Objection submission COM/2019/81 -

Dewatering Issues and lack of 'Dewatering Management Plan'

Attachment A11 - Existing Site Conditions Map (from Stormwater Management Plan)

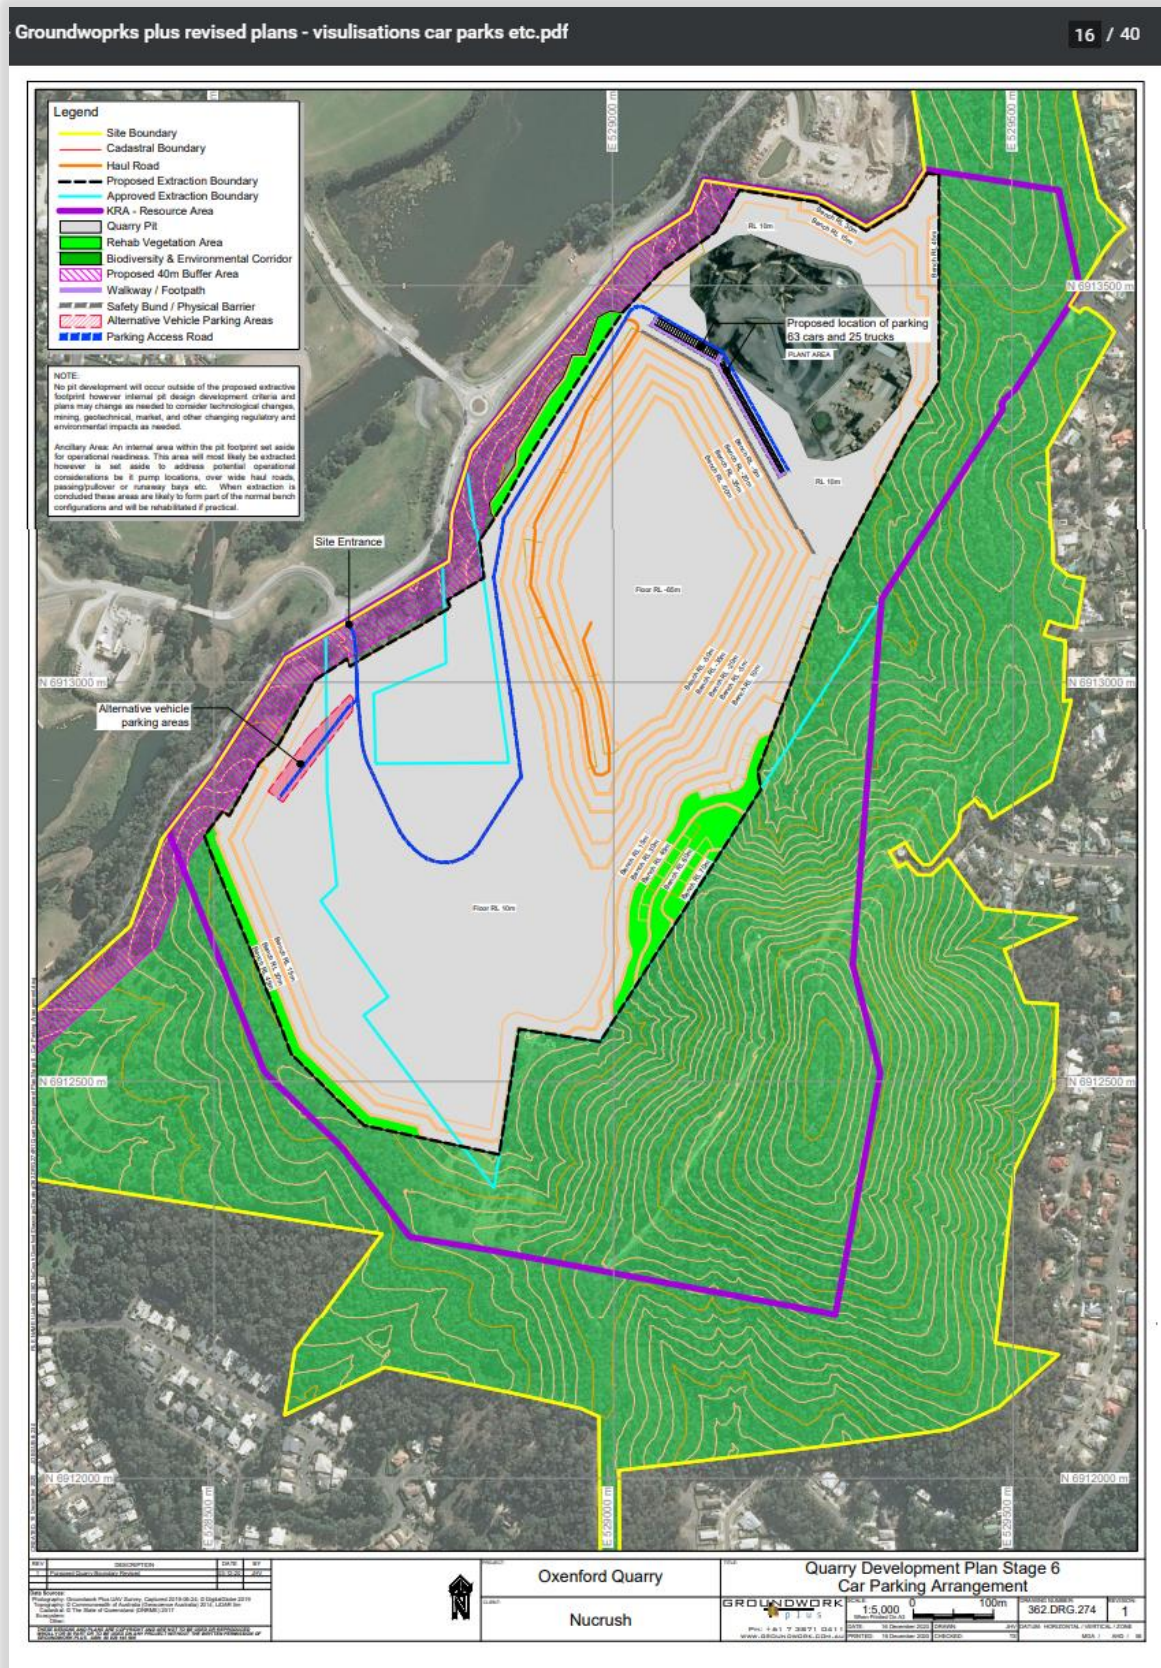
It should also be realised from early stages onwards the existing sedimentation basins and containment pits, dams etc. (as shown in Attachment A11) are engulfed into the extractive footprint and appear to have no replacements planned (as shown in attachment A12) over and above the main sump in the foot of the quarry (as shown in Attachment A7). Therefore, there is nowhere to store the excess water to ensure its safe prior to pumping into the Coomera River.

Attachment G1 - Groundwater Impact Assessment - Conceptual Cross Section Fig 7.2

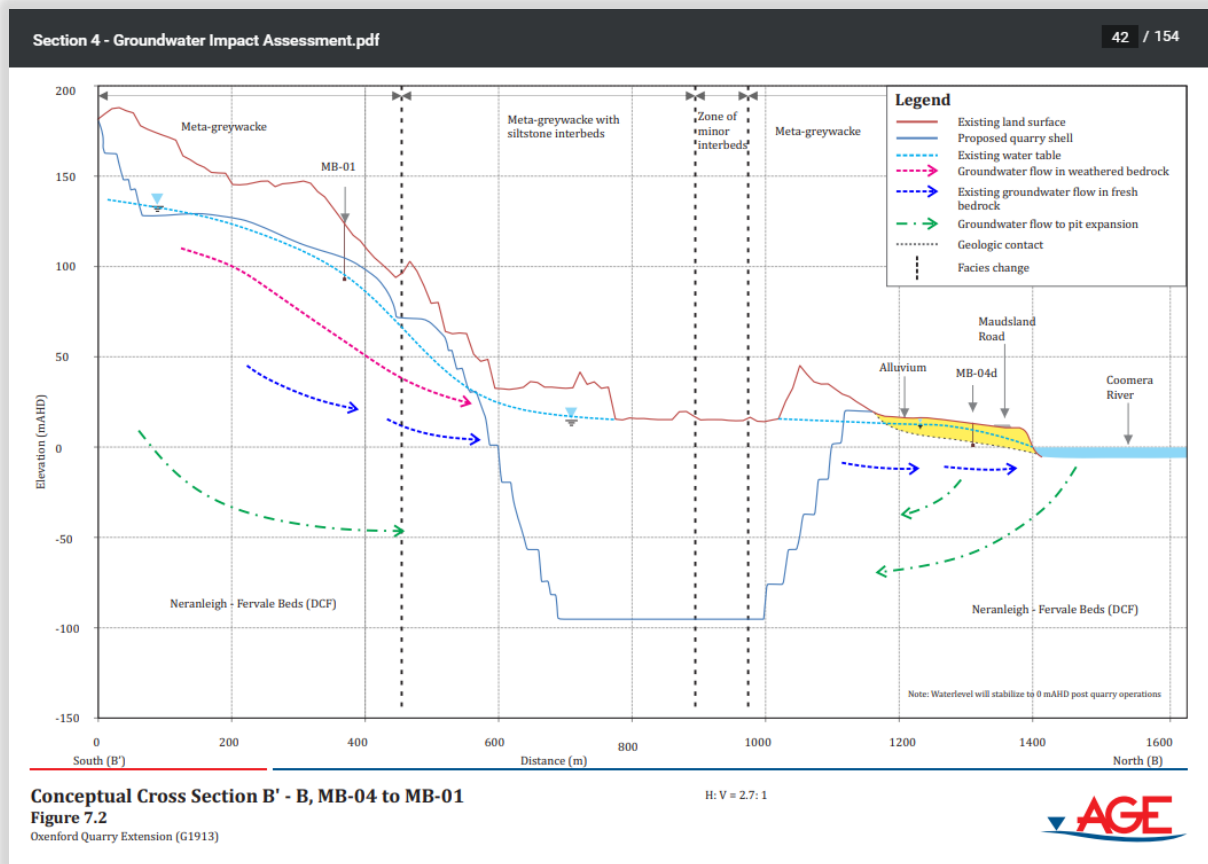
Current Water Table (from '*Conceptual Cross section*' current operations, attachment G1):

Attachment G3 - Groundwater Impact Assessment, Conceptual Cross Section during operations Fig 7.3

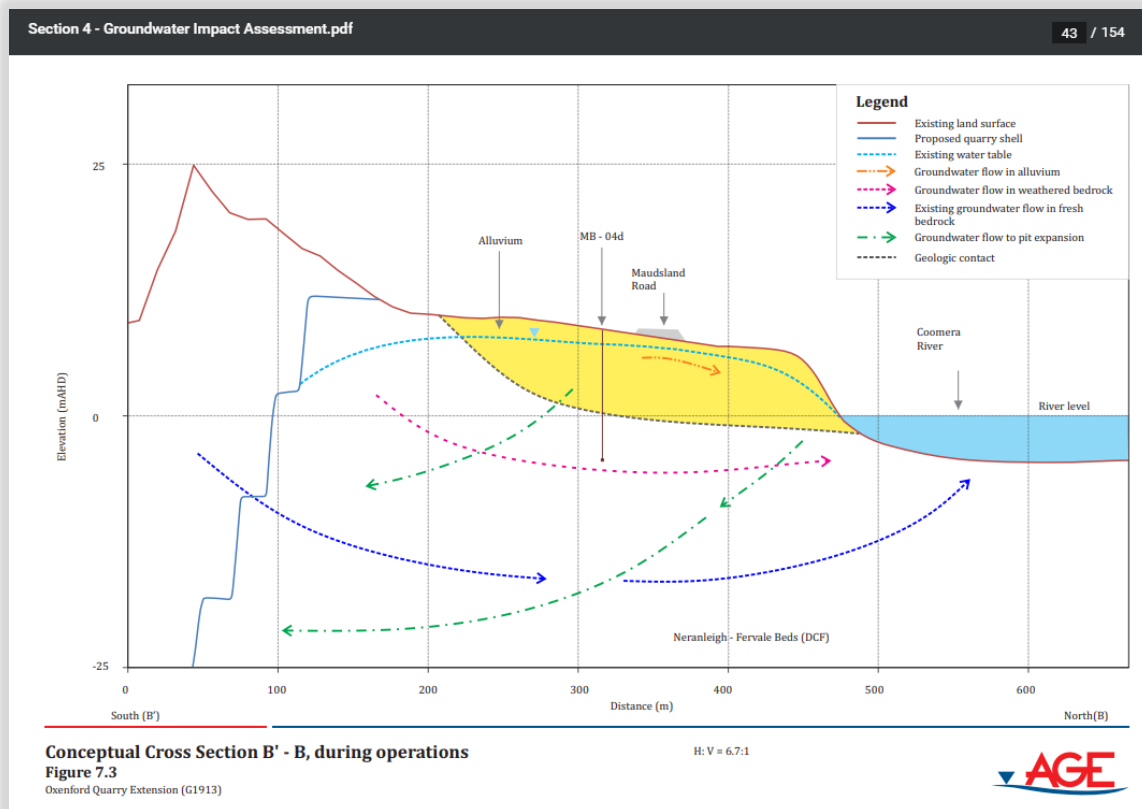
I do not believe this *'Conceptual Cross section during operations'* (attachment G3) shows the true extent of the effect this will have on the groundwater in the area. In fact, if you compare the area labelled *'Alluvium'* (between the Quarry and the Coomera River) from the current situation (Attachment G1) to the during operation I believe inconsistencies emerge as listed below.

Please note the area marked as *'Alluvium'* in the *'Conceptual Cross section during operations'* (attachment G3) is somewhat concerning as this would indicate: *"A deposit of clay, silt, and sand left by flowing floodwater in a river valley or delta, typically producing fertile soil"* Is this development application seriously suggesting this area is not part of the Neranleigh Fernvale Beds? And, the Tamborine-Oxenford Road and the John Muntz Bridge are built on an area of *'Alluvium'* and not solid Rock? If this was the case, why does this not get washed away by stormwater? I would question the accuracy of these diagrams.

Attachment L1 - Groundwater Impact Assessment - 'Conceptual Cross-Section A-A'

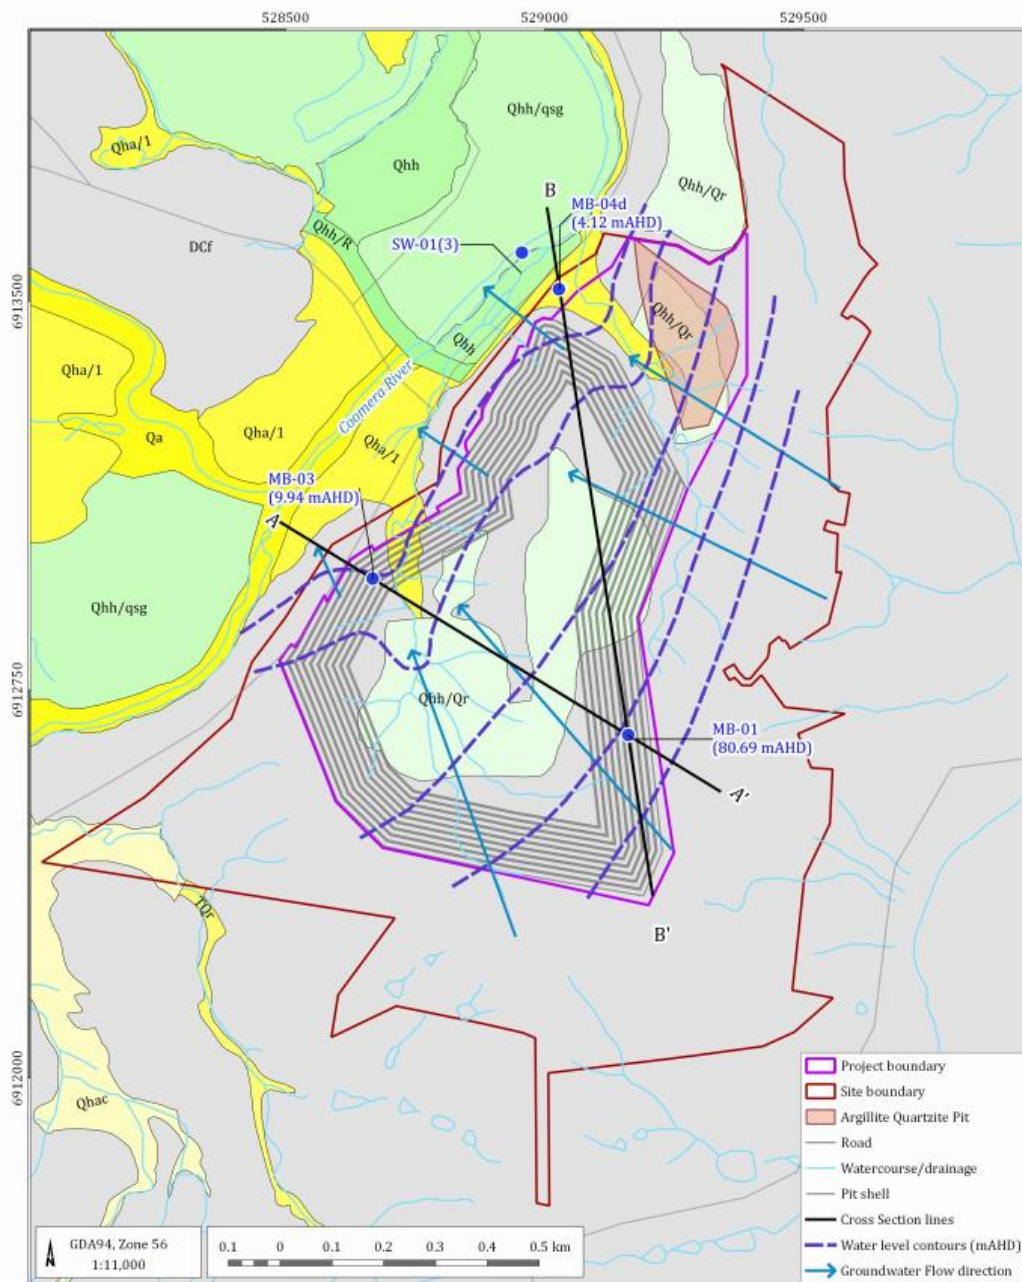
For instance the '*Conceptual Cross Section at A-A*' is shown in attachment L1 shows the '*Existing water table*', prior to subterranean quarrying, however, negligently in my opinion, fails to show the '*Conceptual water table*' as would seem highly important.
